GROUP	MODEL
ELE	2024-2025MY EV9 (MV1)
NUMBER	DATE
398	September 2025

TECHNICAL SERVICE BULLETIN

SERVICE ACTION: SBW GEAR SELECTION LOGIC IMPROVEMENT (SA626)

Upgrade Event #842 (MV1)

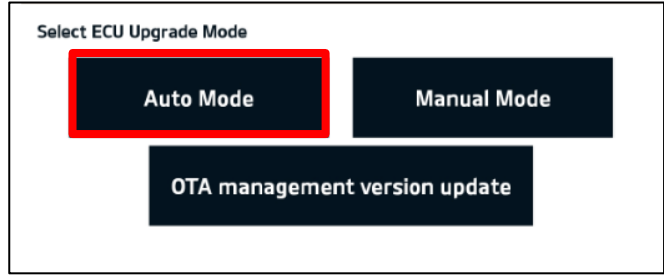
Model	System	IMMO	ECU P/No.	ROM ID	
				Previous	New
MV1	E-SHIFTER	Yes	467W0-DO110	1.00	1.01
			467W0-DO100	1.02	1.05
				1.03

To verify the vehicle is affected, be sure to check the Calibration Identification of the vehicle's ECM ROM ID and reference the Information Table as necessary.
